Subject: Leeston Stormwater Bypass Contaminated Land Review
Attention: Daniel Meehan, Emma Taylor
From: Louise Wilson
Date 17 August 2022
Document No. SDC-014-MEM-001_Rev1

Selwyn District Council (SDC) are undertaking a project called Leeston Stormwater Bypass in Leeston, Canterbury. The stormwater bypass alignment intersects part of 60 Leeston Dunsandel Road (Lot 2 DP 365379), which is listed on Environment Canterbury's Listed Land Use Register (LLUR) as a Hazardous Activities and Industries List (HAIL) site. As part of the Leeston Stormwater Bypass project, SDC is planning to purchase a 17m wide (0.3853 ha) strip of land along the northern boundary of 60 Leeston Dunsandel Road. This land is required for construction of the bypass channel. However, contaminated site investigations undertaken to date report that contamination is present within soil in this 17m wide strip.

SDC has engaged Taylor Collaborations Ltd (Collaborations) to undertake a review of the contaminated site investigation reports currently available for 60 Leeston Dunsandel Road (site map in **Appendix A**).

Figure 1 Excerpts from Aurecon design drawings showing the 17m strip of land to be purchased, proposed bypass design within 60 Leeston Dunsandel Road and construction details

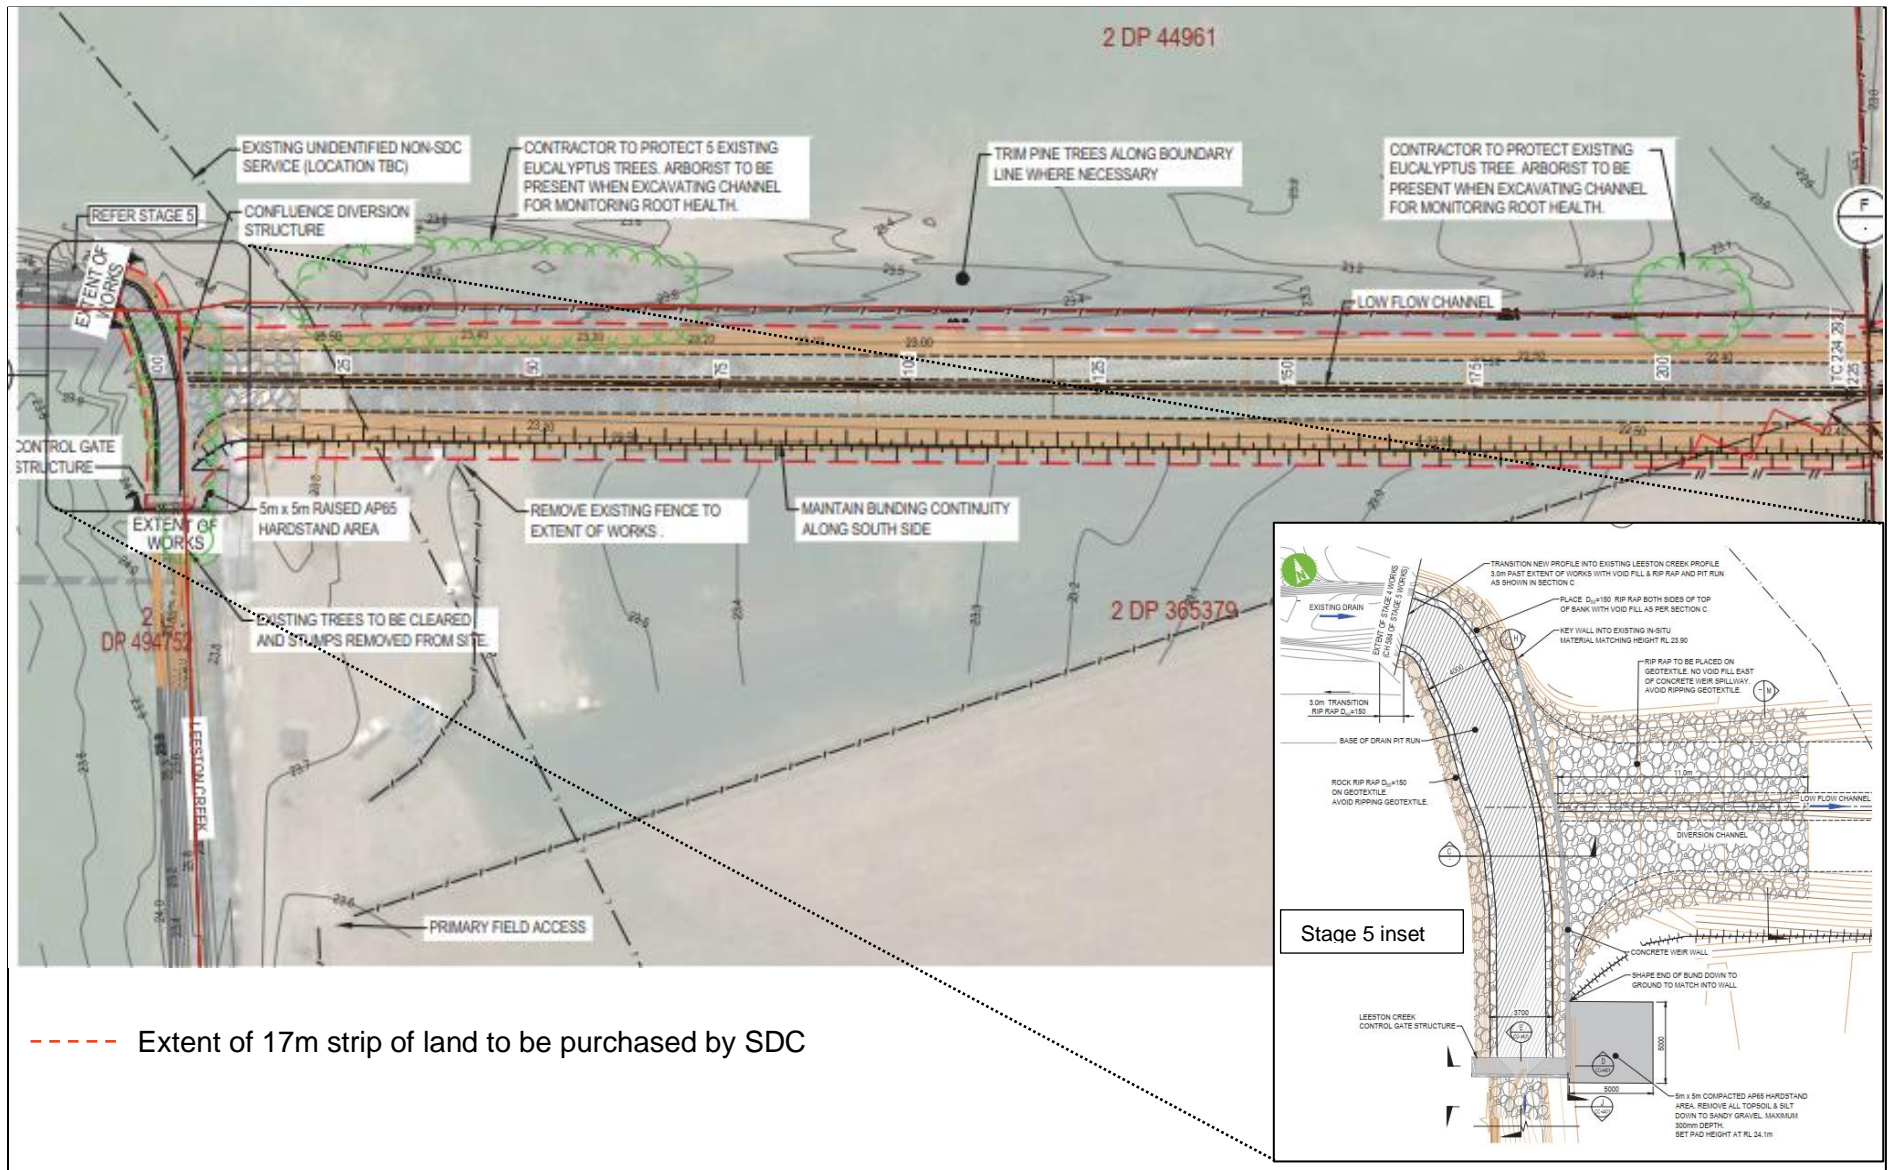
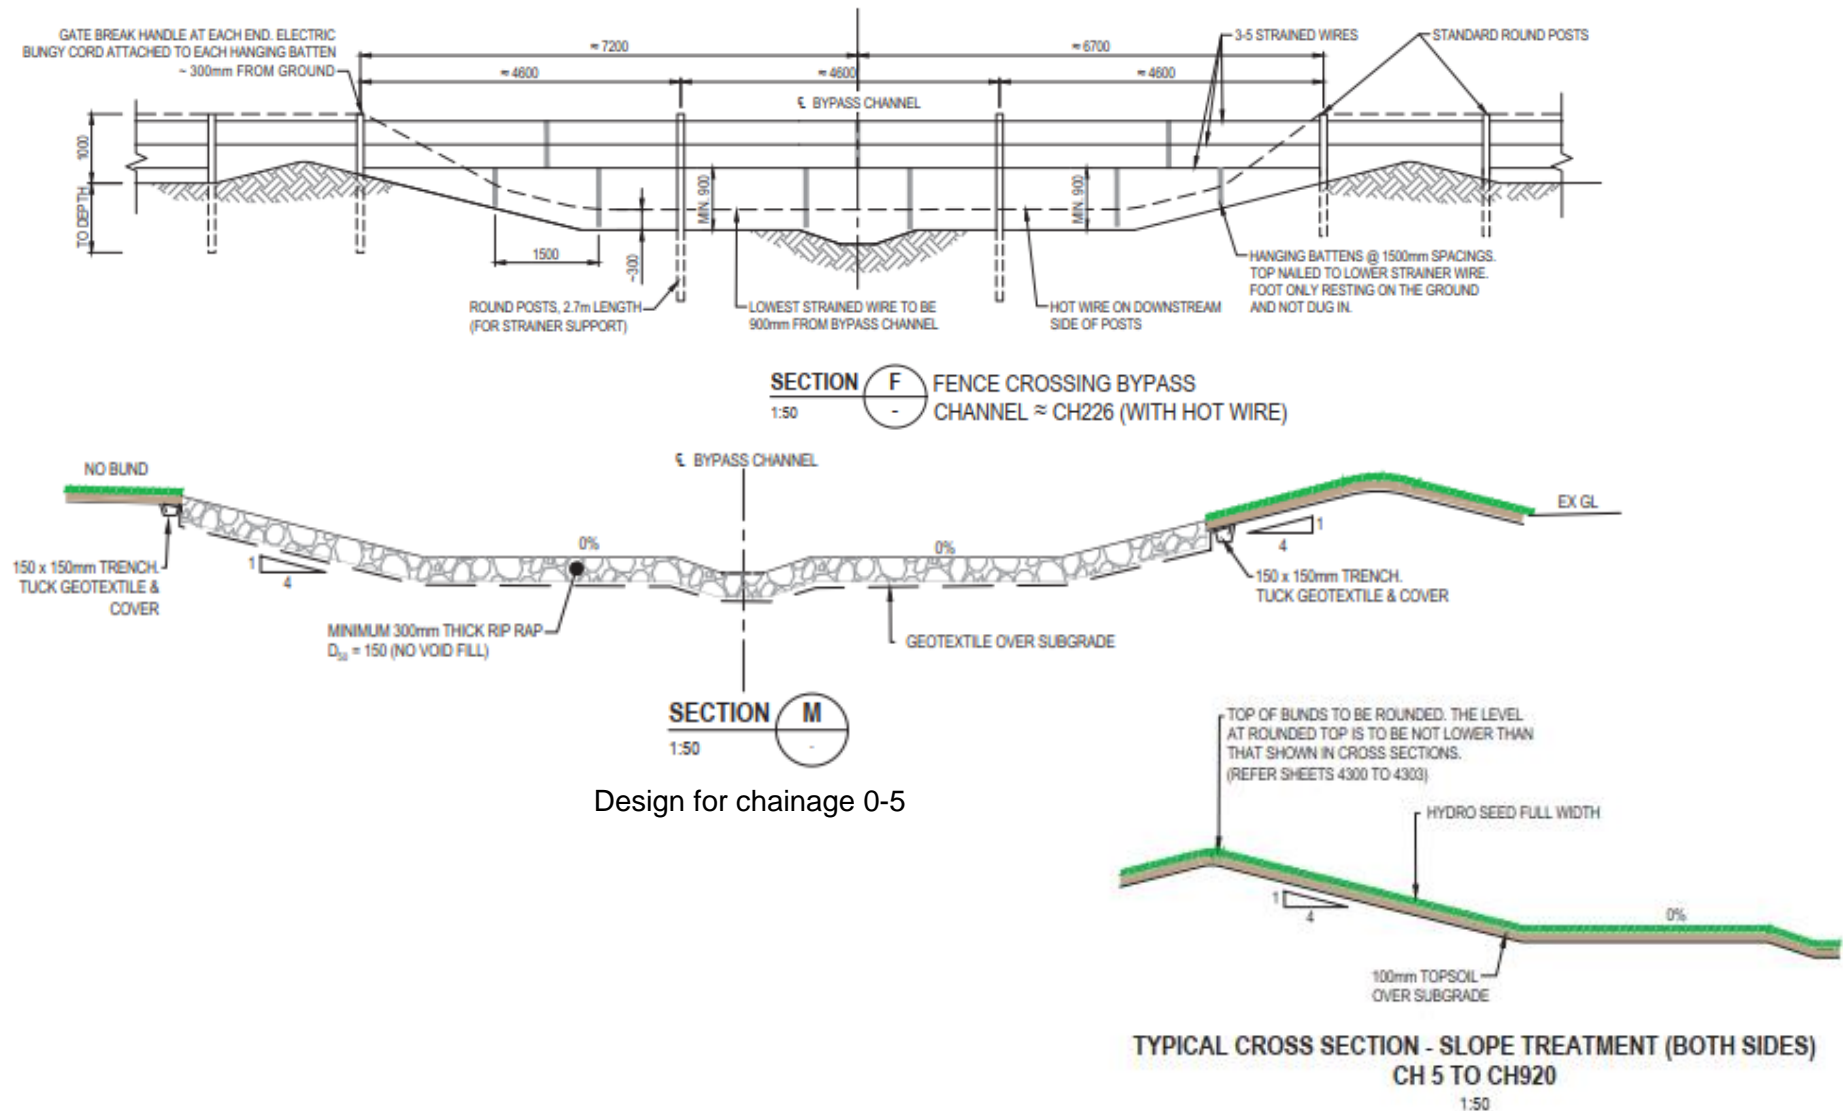
- The proposed excavation within the 60 Leeston Dunsandel Road boundary is approximately 2,500m³ over an area of approximately 3,842m². This exceeds the permitted activity threshold for soil disturbance, therefore consent under the NESCS will be required for the works to occur.

- The excavated 2,500m³ of soil will need to be managed. This could be via removal to an appropriate offsite location, or retaining the material onsite through the creation of a soil bund or similar on the southern boundary of the channel.

- The consent application will require a supporting Detailed Site Investigation which provides results for the soil that will be excavated.
- The DSI should consider the effects to both human health receptors (construction workers and future end users e.g., recreational users) and ecological receptors as the bypass may become habitat for birds and/or aquatic life.

Figure 3 Map from Momentum Environmental DSI showing soil sampling locations, contamination results and the 17m strip of land to be purchased by SDC (white dotted line).

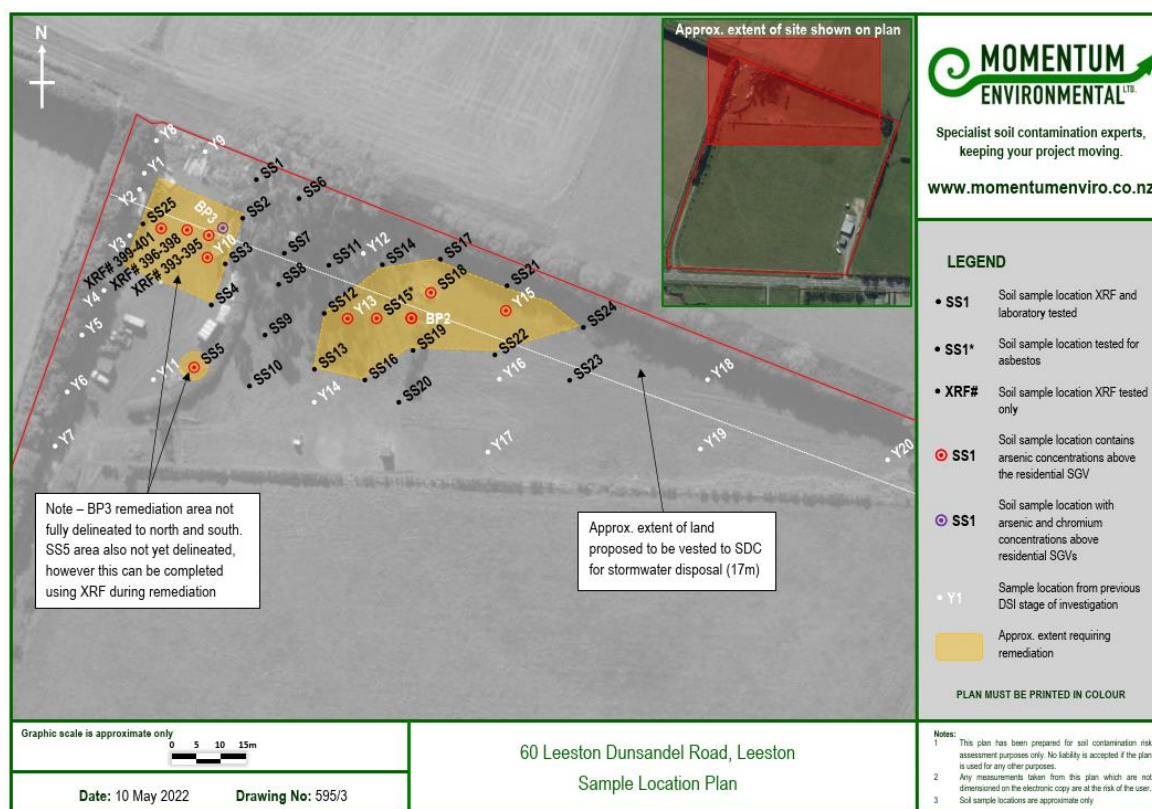
It is considered that the previous investigations were suitable for the purposes of the proposed residential development. However, as the planned excavation for the channel will reach up to 1.2m bgl, further investigation and consenting specifically for the excavation of soil for the bypass channel is required. The following should be noted:

The property owners have consent under the NESCS (RC225368) to undertake the remediation proposed by Momentum Environmental Ltd. It is unknown when this work is planned to occur. The proposed remediation intersects the 17m strip of land to be purchased by SDC in burn pit locations BP2 and BP3 (see **Figure 3**).

- It is recommended that a copy of the Site Validation Report is provided to SDC prior to purchase of the 17m strip of land (if the remedial work has been undertaken by this time).

Figure 5 Stage 5 alignment of stormwater bypass channel and boundaries of land parcels intersected, showing closest HAIL site 250m north of the alignment (Gilberts Pit, within 198 Harmans Road).

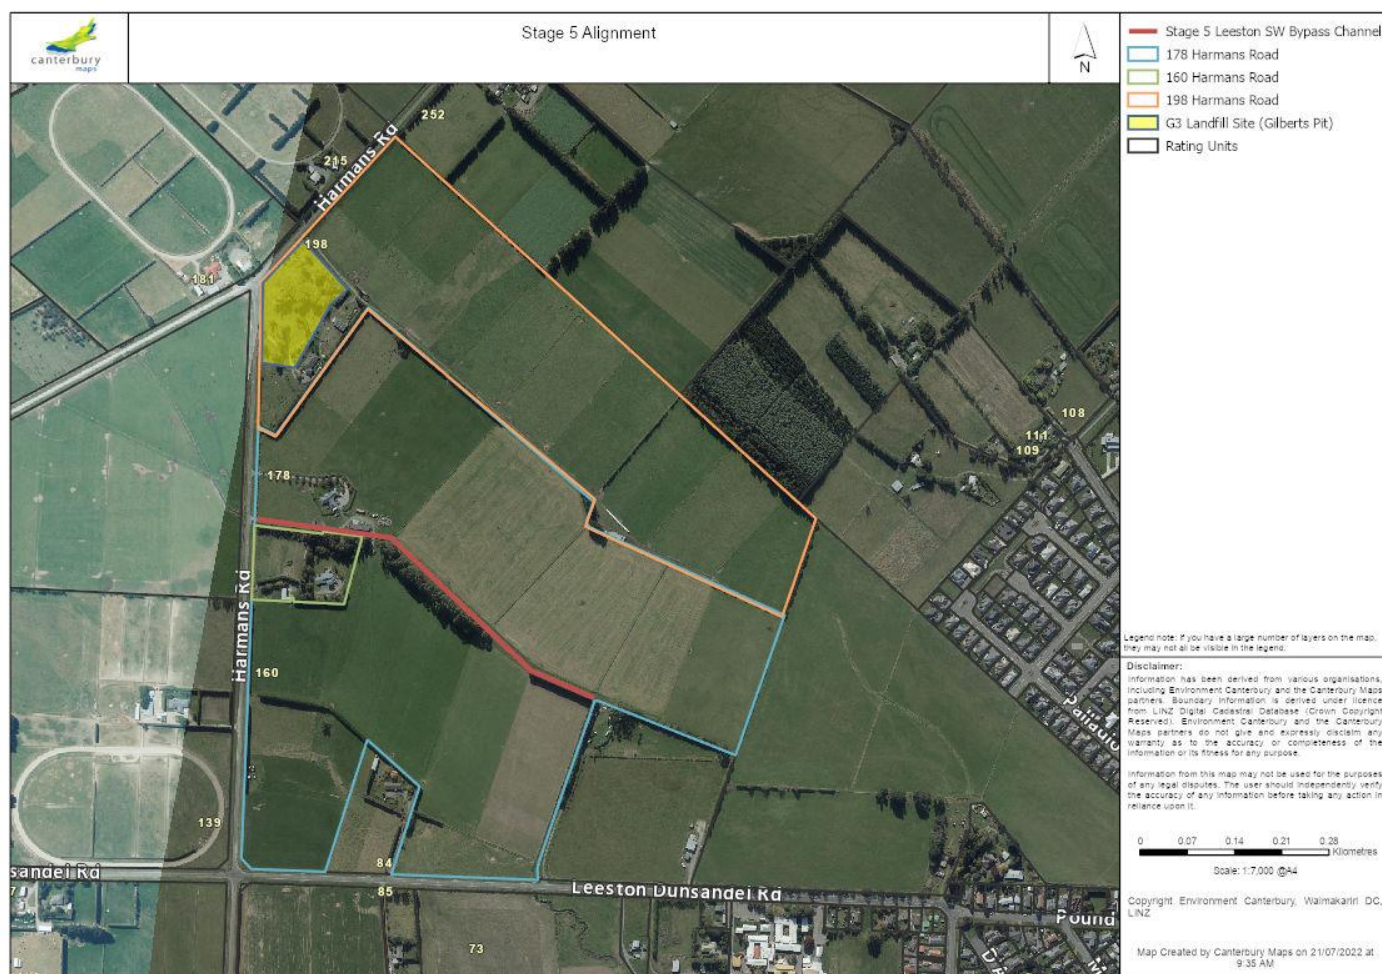
198 Harmans Road (Lot 1 DP 44961) includes a G3 landfill site, the former Ellesmere Country rubbish dump known as Gilberts Pit. It is located approximately 250m north of the Stage 5 alignment and is therefore not considered to present a risk to the project, as there is no plan to disturb soil within 198 Harmans Road.
